PLANNING

Client:
-
Project Title:
24 Heath Drive, London, NW3 7SB

Drawing Title:
Internal Elevations
First Floor - Master Dressing Room

Project No.: 508-16 Drawing No.: 3109 Revision: C

Proposed First Floor

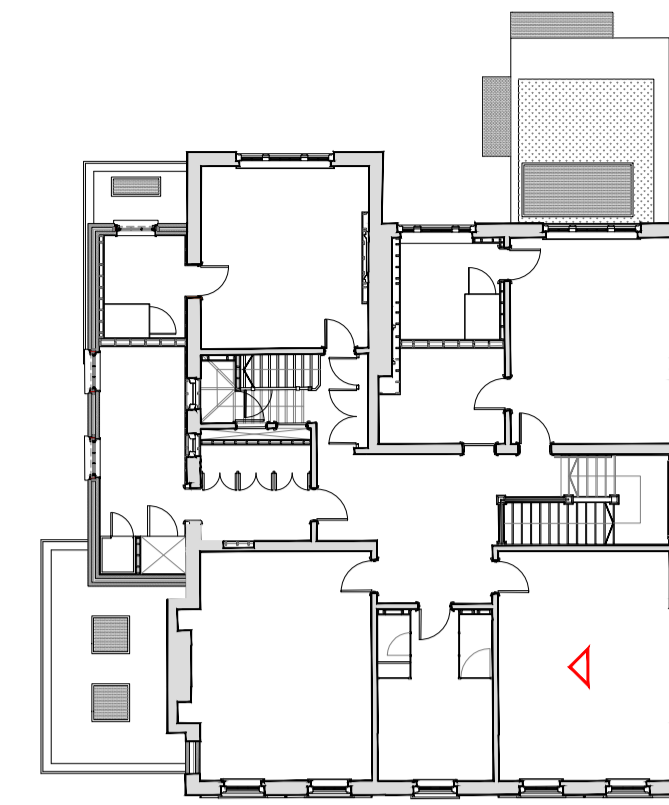
Summary of changes:

- Door location to be shifted
- Door direction to be flipped
- New door inserted in original partition; refer to detail
- New architrave to match existing

Proposed Internal Elevation

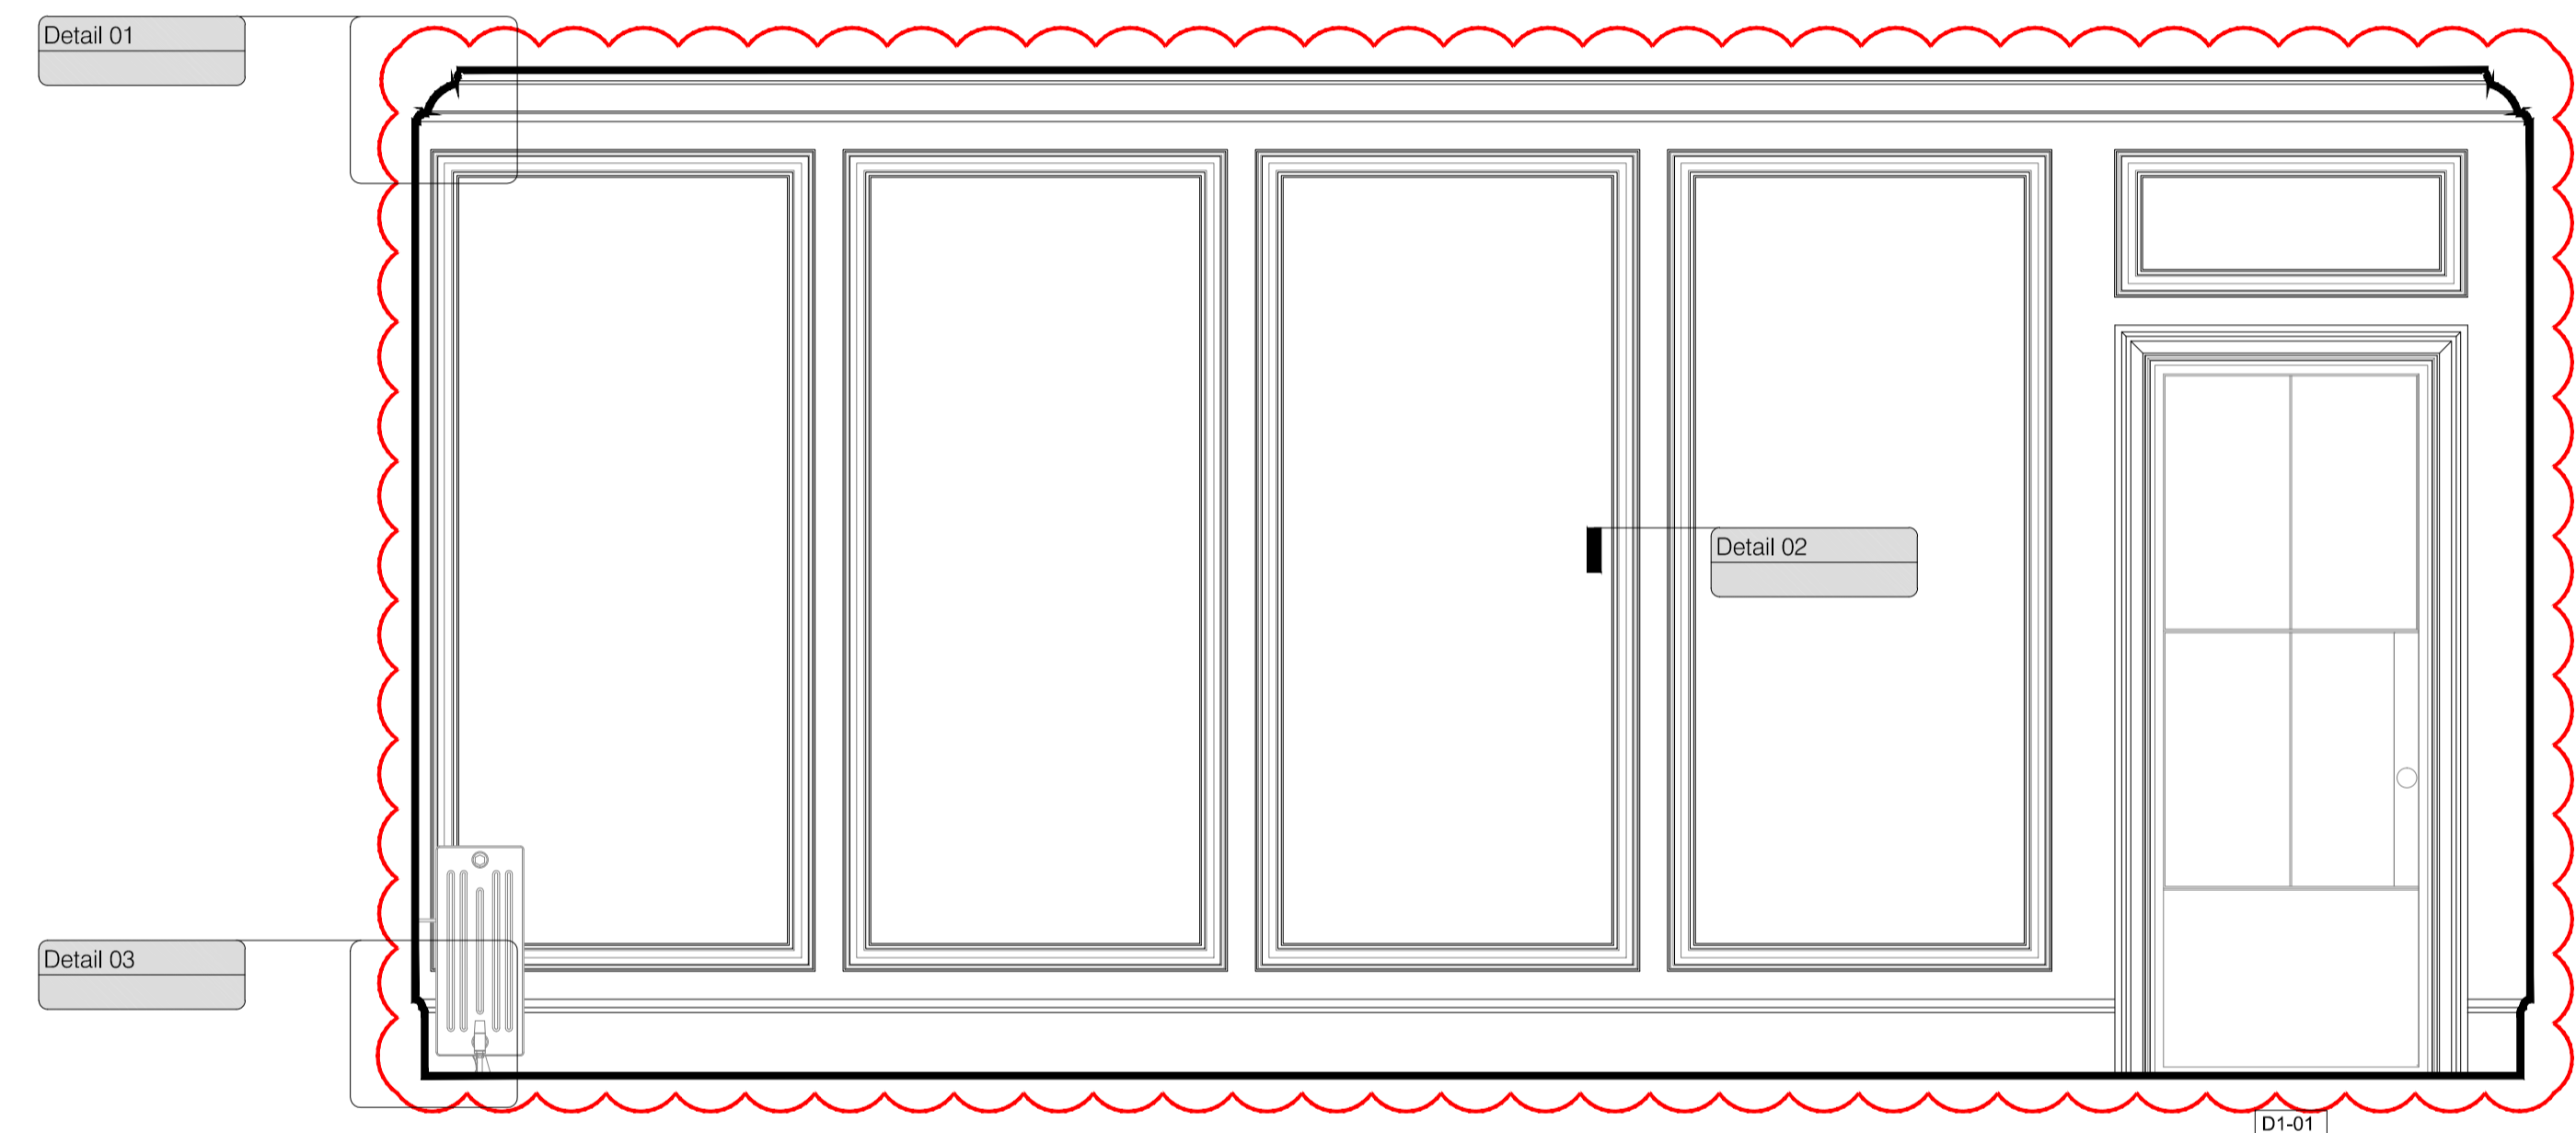
Summary of changes:

- Existing door opening to be reused
- New architrave to match existing
- New Door in existing opening to be slim framed metal and glazed panel door system, to differentiate between original and new building fabric.
- Previously approved new opening to be infilled with materials to match existing
- New panel moulds to be installed to be in keeping with profiles inground floor principle front rooms
- New skirting to be in keeping with profiles inground floor principle front rooms
- New cornice profile to be installed to be in keeping with profiles inground floor principle front rooms
